### **REMARKS/ARGUMENTS**

**Serial No.:** 10/712,327      **Title:**  
**Elec. Motor Driven Hand Held Tool**  
**Inventor:** Daniel Craven, et al.  
**Docket No.:** P-US-PR 1091  
~~Replacement Sheet~~ 2 of 2  
*Annotated*

PRIOR ART  
 FIG. 1

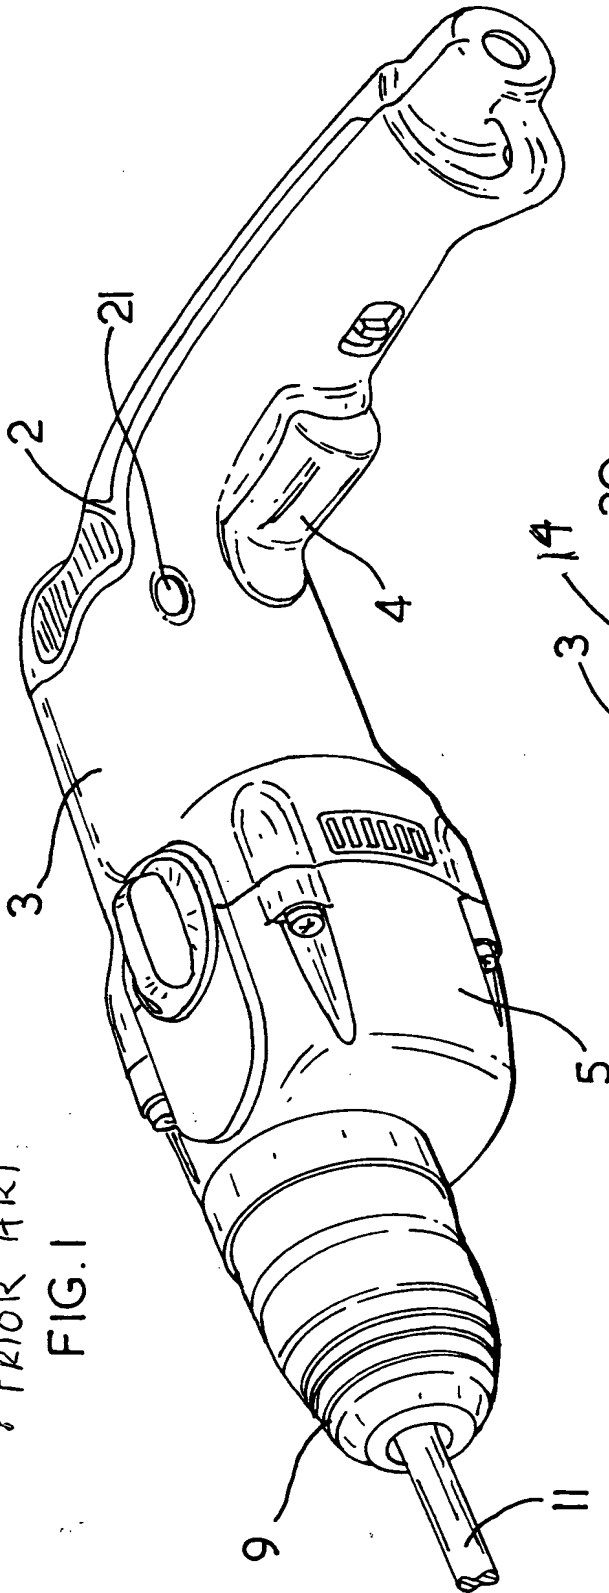
The Drawings stand objected to as informal and do not conform with current US practice. Additionally, Figure 1 is not properly labeled as "Prior Art."

- the drawing quality has been improved to conform to US practice;
- Fig. 1 has been labeled as "Prior Art";
- in Fig. 2, reference number 28 has been deleted;
- in Fig. 2, reference number 14 has been added; and
- in Fig. 4, reference number 26a has been substituted for reference number 15.

Replacement drawing conforming to US practice are submitted and Figure 1 has been labeled as prior art. Furthermore, during preparation of this Amendment, it was noted that the Specification and Drawings use reference number (15) to refer to both the motor and the "rearward edge of the upper portion of the motor housing." Therefore, Figure 4 is amended to use reference number (26a) to refer to the rearward "rim" of the upper portion of motor housing (3). The addition of reference number (14) and deletion of reference number (28) from Fig. 2 is purely editorial.
